Having assessed your plans and specifications, we require the following additional details / amendments to ensure compliance is properly demonstrated and enable building consent to be issued:

PROJECT INFORMATION MEMORANDUM
 ISSUED UNDER SECTION 32 OF THE BUILDING ACT 2004
 DATE: 16.3.15 P.I.M. No: # 73495
 OFFICER: A Kelly

Relocated House + Extension + Decks at 47 Mamaku St. Mamaku

Subfloor plan 1:100

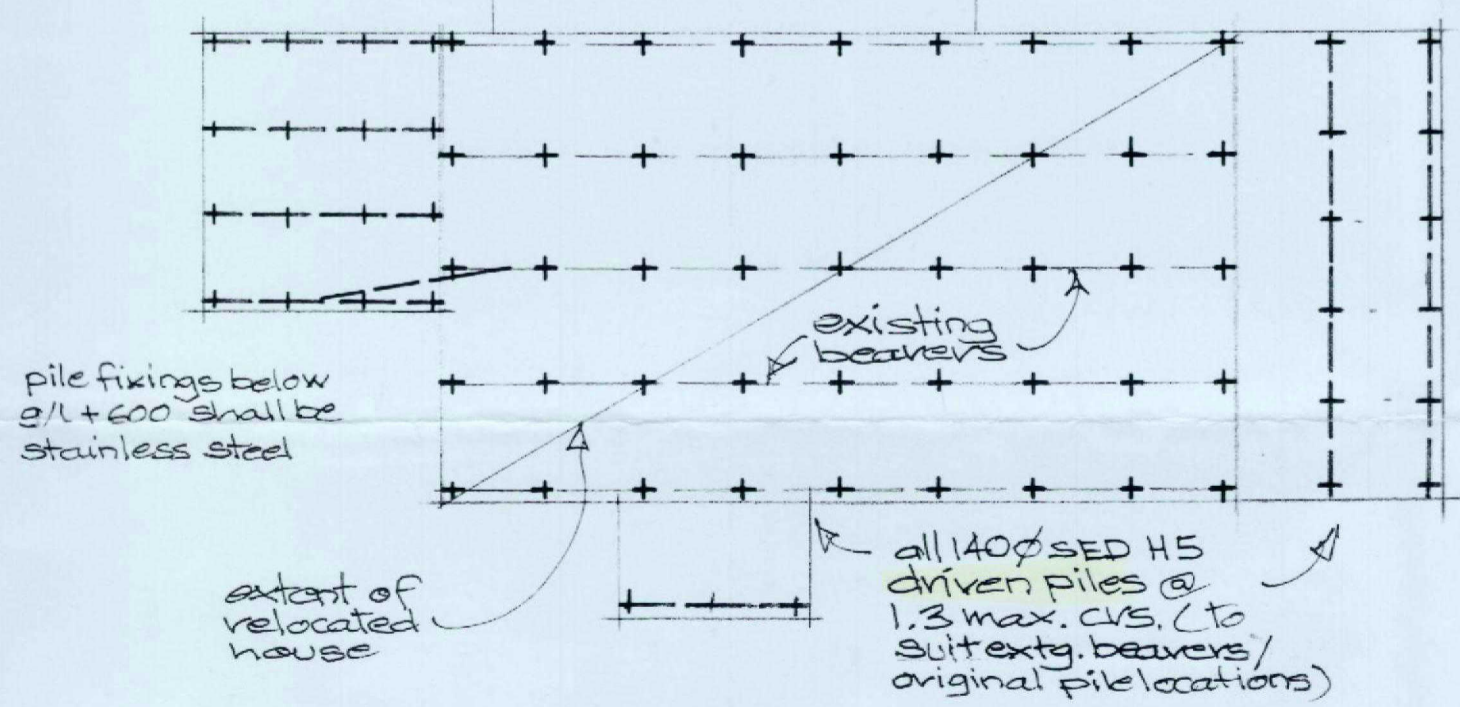
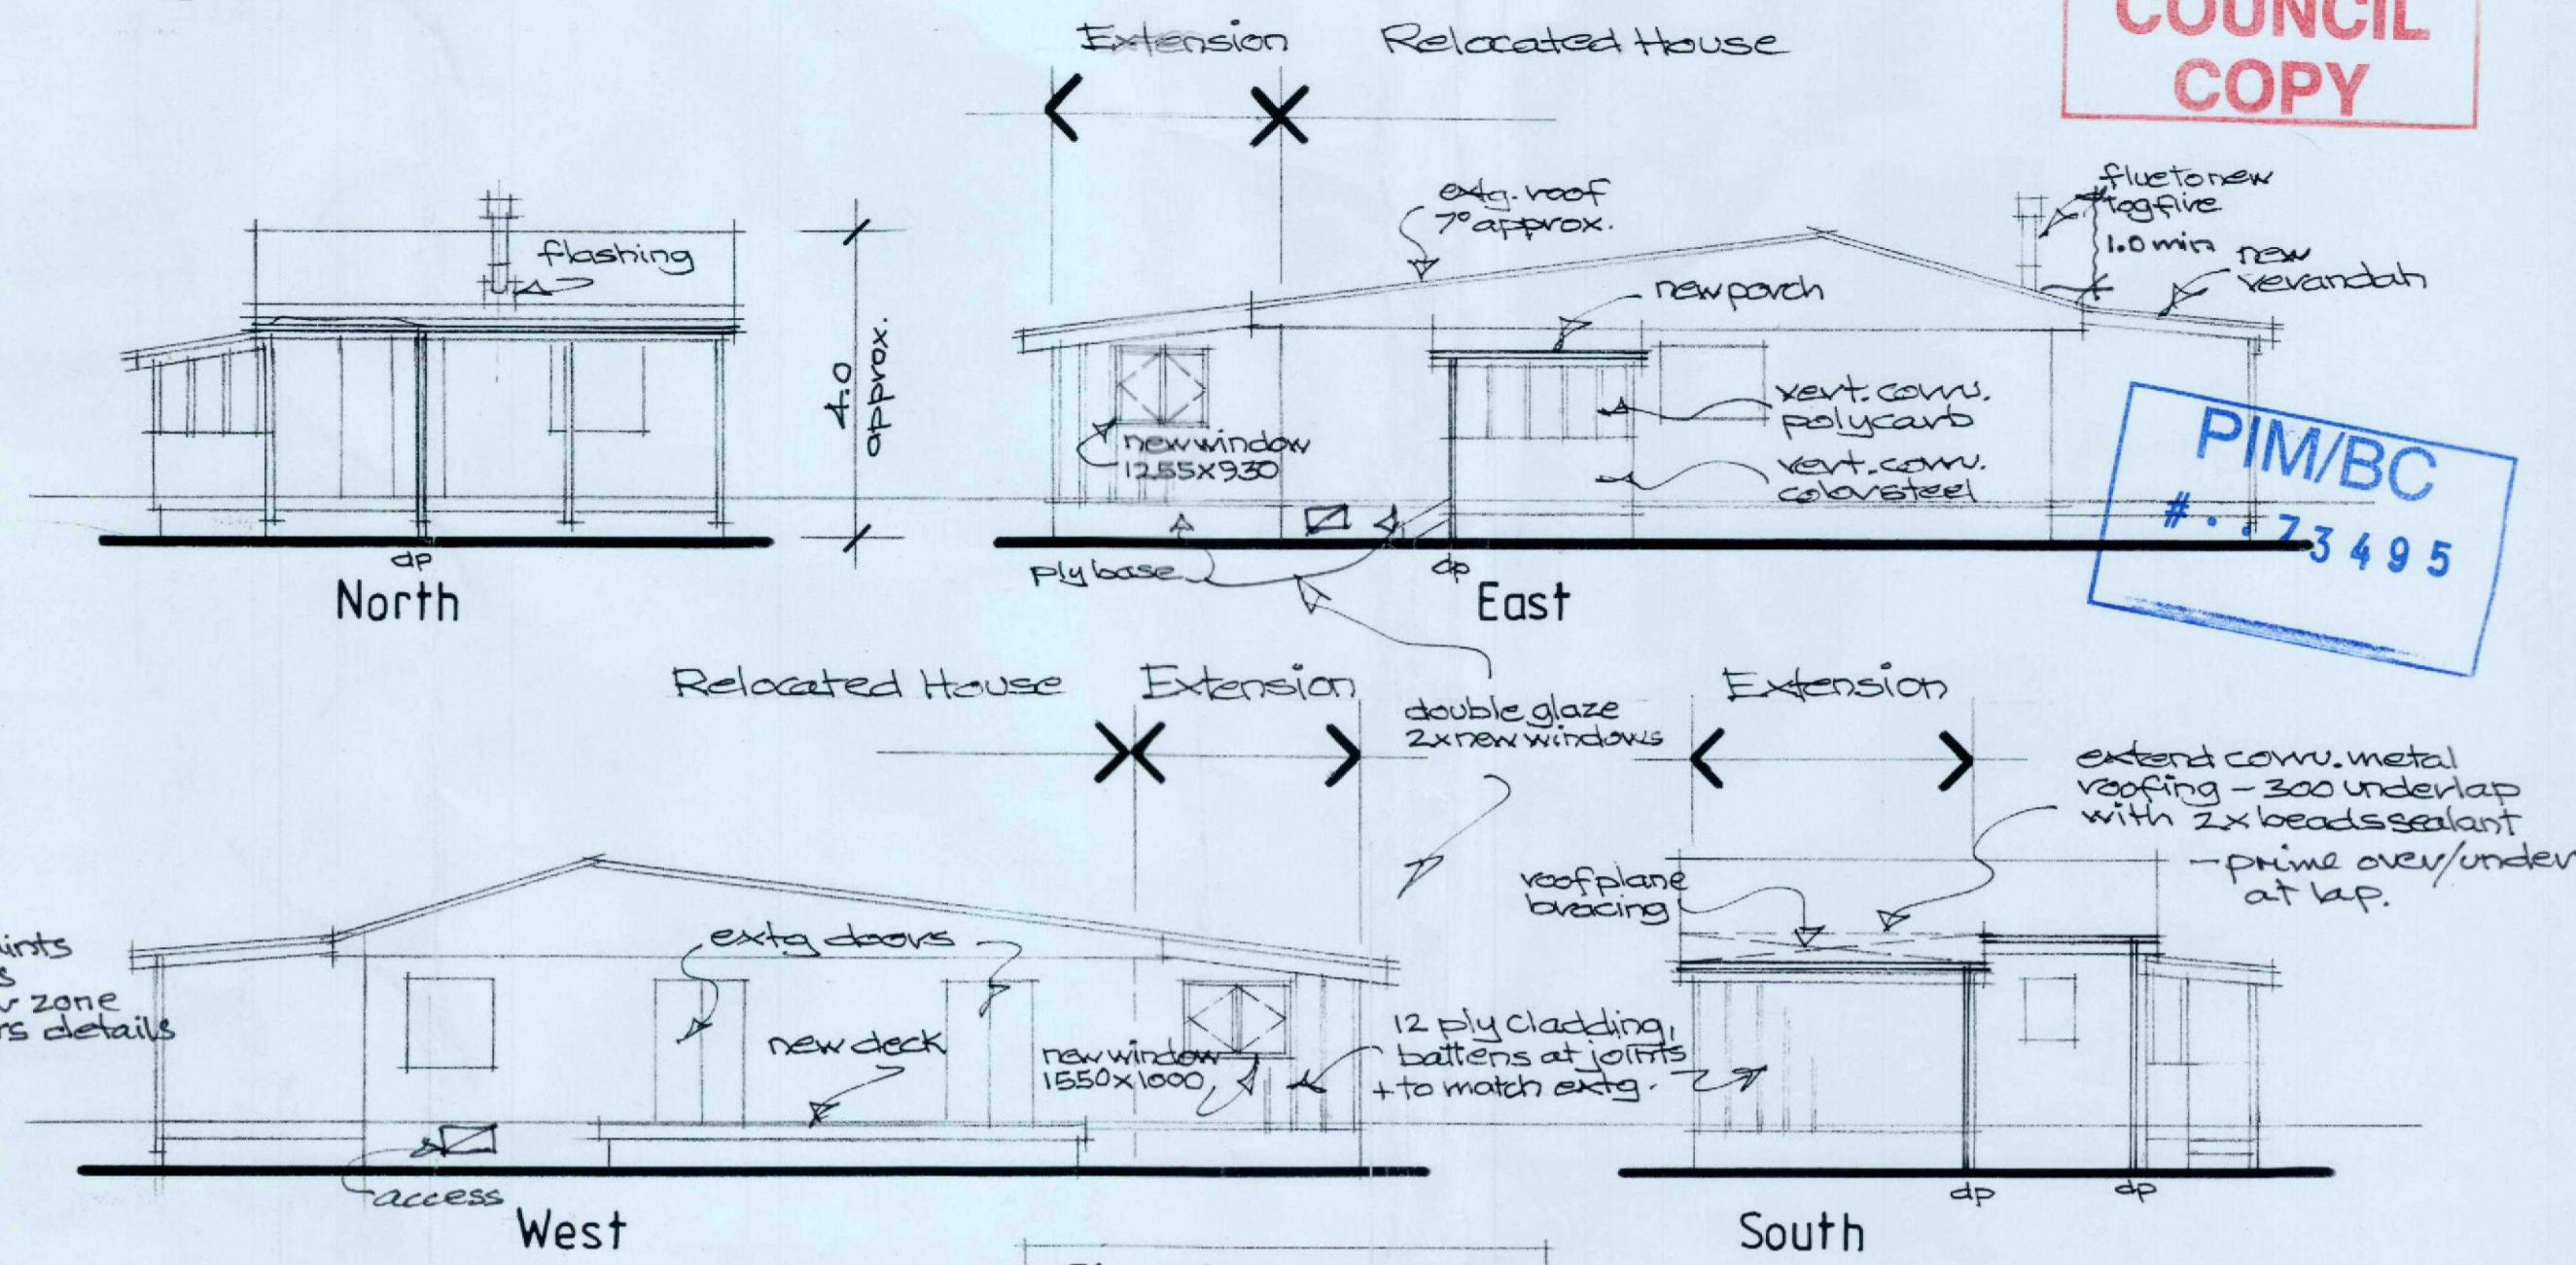
1. NZS 3604:2011 is noted as one of your means of compliance for structure, the following details need to be amended or submitted to demonstrate compliance:
 - Subfloor skirt (solid or Slates) Ventilation must be noted on plans, also indicate location of access panel.
 - Finish floor height to be noted on plans.
 - Bearer treatment to be noted on plans.
2. Building wraps to be indicated on plans for both roof and walls.
3. Roofing material (New) to be confirmed durability requirements will be met in connection with the existing roof cladding. If additional priming is required for compatibility a note must be added on the plans.

Figure 8A: Soffit/wall junction
Paragraphs 8.3, 8.4.3.1, 8.4.6, 9.7.5, 9.8.6

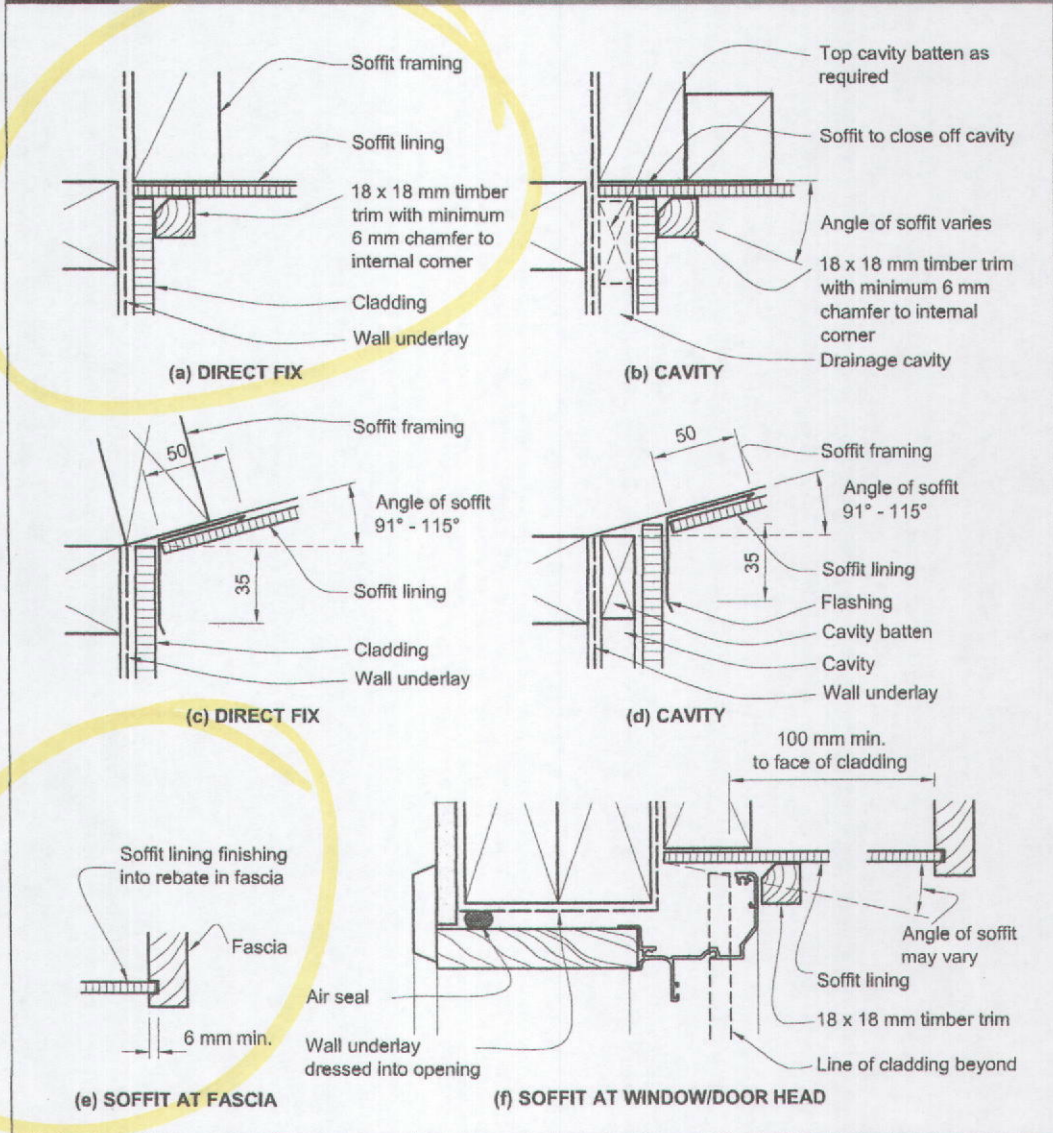
4. Wall soffit junction to be added to plans *ref NZBC E2/ AS1*.
5. Solid Fuel Heater requires the following points clarified:
 - Flue Height and specifications.
 - It shows on the floor plan the location of the solid fuel appliance will be close to the existing doors, confirm which way the curtain will open, if they are behind the appliance
 - Curtain restraints are required and clearance distances still adhered for.
